February 8, 2001

Subject: Peach Bottom Atomic Power Station, Units 2 and 3
License Change Application ECR No. 99-00015

License Change Application ECR No. 99-00015

Figure 3.4.1-1 (page 1 of 1)
THERMAL POWER VERSUS CORE FLOW
STABILITY REGIONS

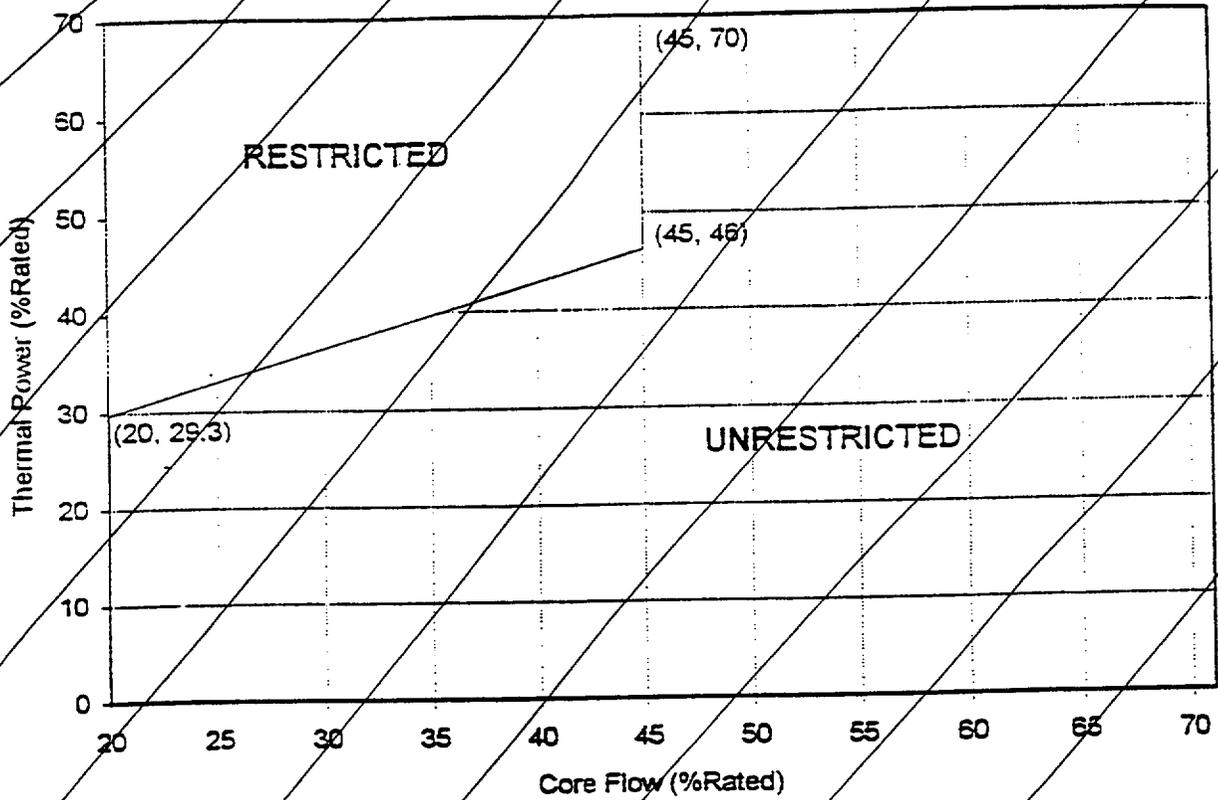
LCO restrictions on operating region (references to Figure 3.4.1-1) will be deleted from the LCO both for two loop and single loop operating conditions. Conditions A, B and C

and their associated Required Actions, and Required Action F.1, each associated with operation in the Restricted Region and included previously as part of the ICA actions, will be deleted. These changes, along with deletion of the related Bases discussions, effectively delete the Technical Specification requirements for the ICAs. [Note: The NUMAC PRNM LTR do not address deletion of ICA related Technical Specifications. Therefore, all Specification 3.4.1 changes are beyond those covered by the NUMAC PRNM LTR NEDC-32410P-A.]

Two recirculation loops with matched flows shall be in operation with ~~core flow as a function of THERMAL POWER in the "Unrestricted" Region of Figure 3.4.1-1.~~

One recirculation loop shall be in operation with ~~core flow as a function of THERMAL POWER in the "Unrestricted" Region of Figure 3.4.1-1~~ and with the following limits applied when the associated LCO is applicable:

Figure 3.4.1-1 (page 1 of 1)
THERMAL POWER VERSUS CORE FLOW
STABILITY REGIONS

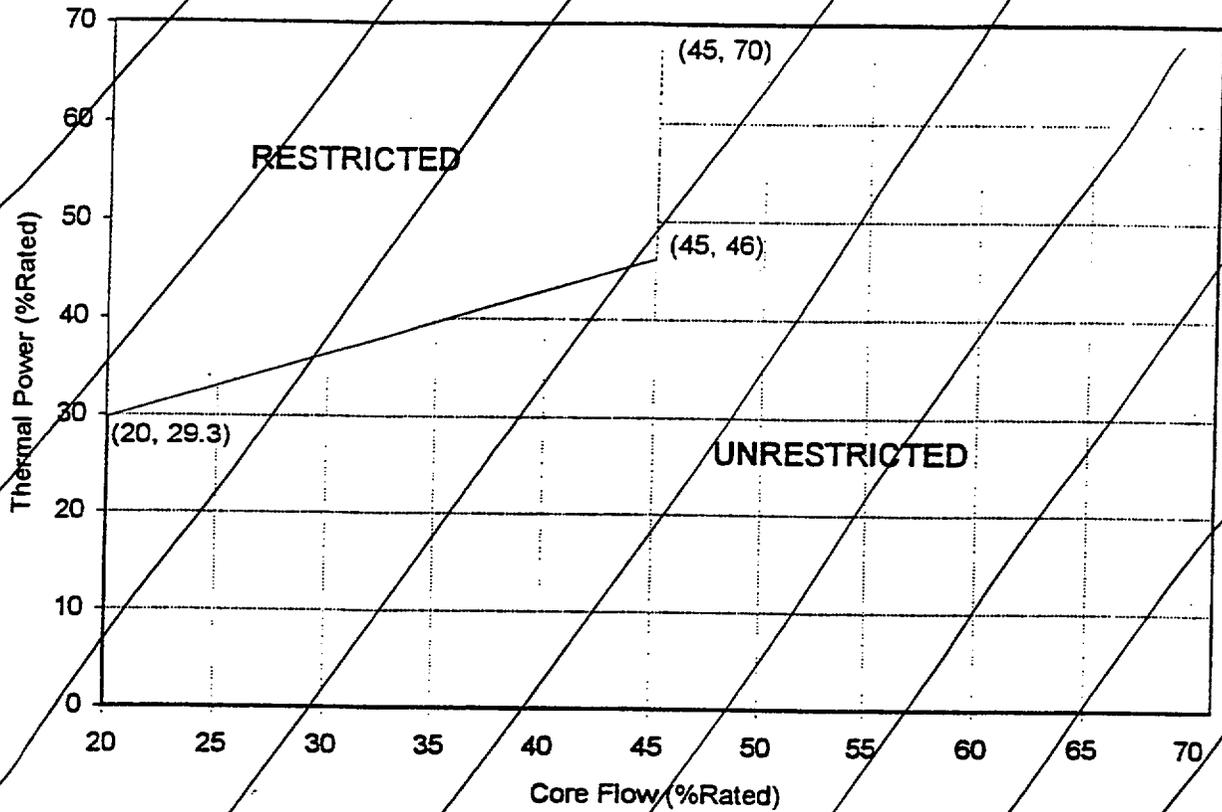
~~Two recirculation loops with matched flows shall be in operation with core flow as a function of THERMAL POWER in the "Unrestricted" Region of Figure 3.4.1-1.~~

~~One recirculation loop shall be in operation with core flow as a function of THERMAL POWER in the "Unrestricted" Region of Figure 3.4.1-1 and with the following limits applied when the associated LCO is applicable:~~
